SEWAGE DISPOSAL SYSTEM

MARYLAND STATE DEPARTMENT OF HEALTH

OLEN KETTENMAN

PROPERTY OWNER ROBT LOWE

P
38424

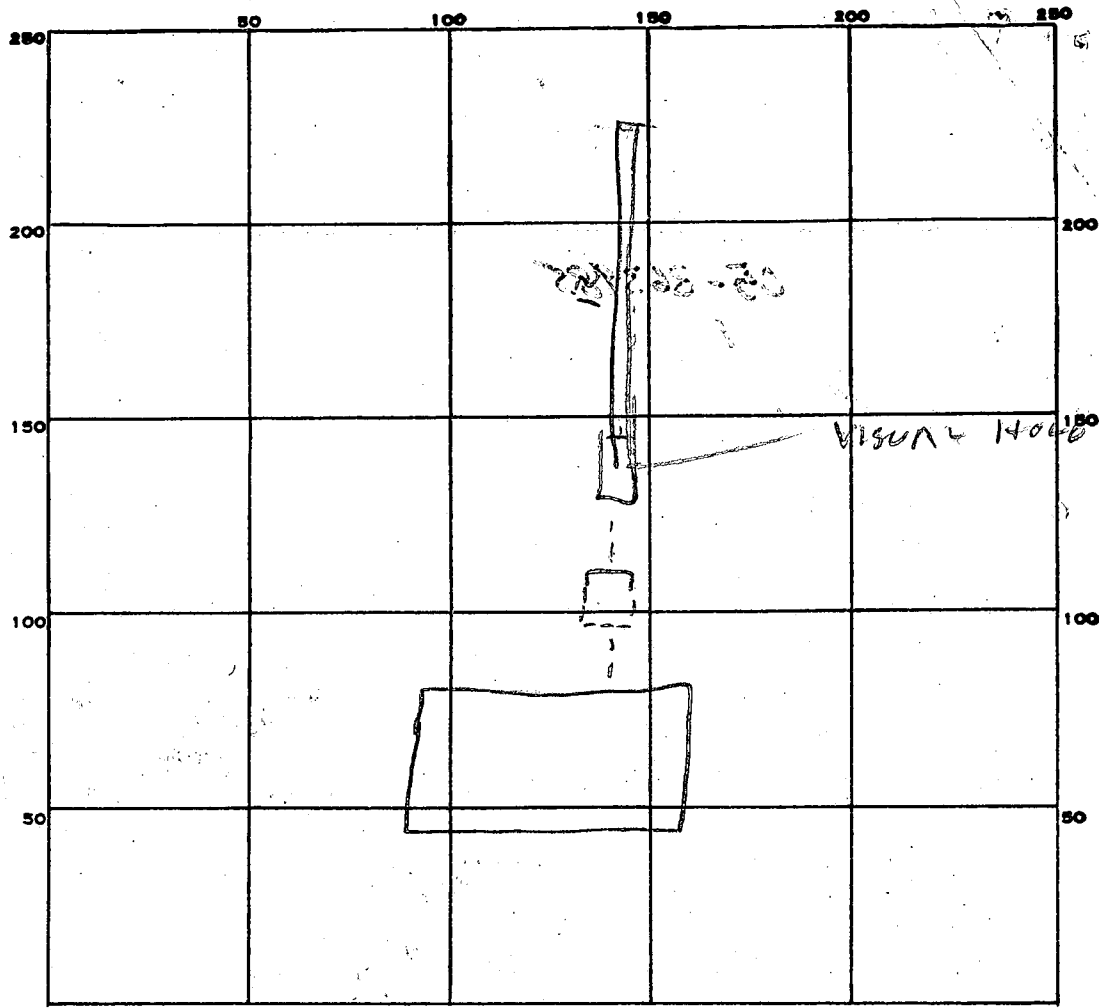
KETTERMAN
INDICATES
EXISTING SMALL
TILE FIELD,
DUG REPAIR HERE

REMARKS 1/6/88 - NOTHING DONE SINCE YESTERDAY BH

1/7/88 - DIG TRENCH LONGER & ADD STONE BH

1/8/87 TRENCH DUG LONGER & STONE ADDED

DATE SYSTEM APPROVED 1/8/87 INSPECTOR Raymond J. Hodges
